PREVOST

WARRANTY BULLETIN

WB18-07B

SUBJECT:	REVERSED BUSBAR AT CIRCUIT BREAKER CB13 - VEHICLES EQUIPPED WITH A CURRENT INVERTER		
l	EXPIRATION:	March 2020		
ı	DATE:	March 2018	SECTION:	06 ELECTRICAL

FIGURE 3: CORRECT INSTALLATION

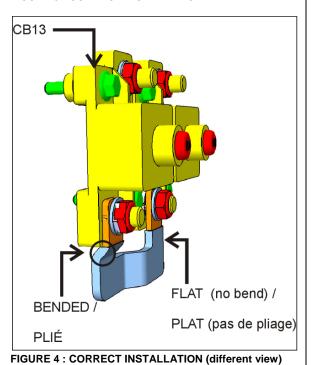
- 2. Check if the busbar is installed correctly. The "flat" on the busbar must be placed on the circuit breaker located on the R.H. side of CB13.
- 3. If the busbar is installed properly, no further verification is necessary.

The "flat" on the busbar must be placed on the circuit breaker located at the R.H. side of CB13.

Nut torque: 135 lbs-in (15 Nm)

FIGURE 5: DISCONNECT THE GROUND CABLE WHERE INDICATED WITH A CIRCLE

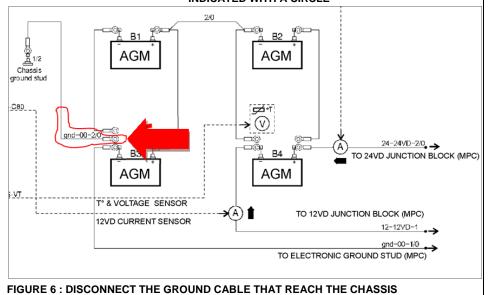
4. Breaker CB13 is connected directly to the battery. Therefore, it is necessary to disconnect the ground cable reaching to the chassis at the battery installation in order to avoid any risk of short circuit during the removal and installation of the busbar.

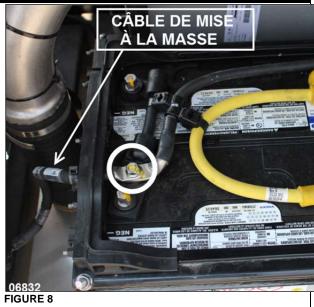
6. Connect the ground cable.

Nut torque: 170 lbs-in (19 Nm)
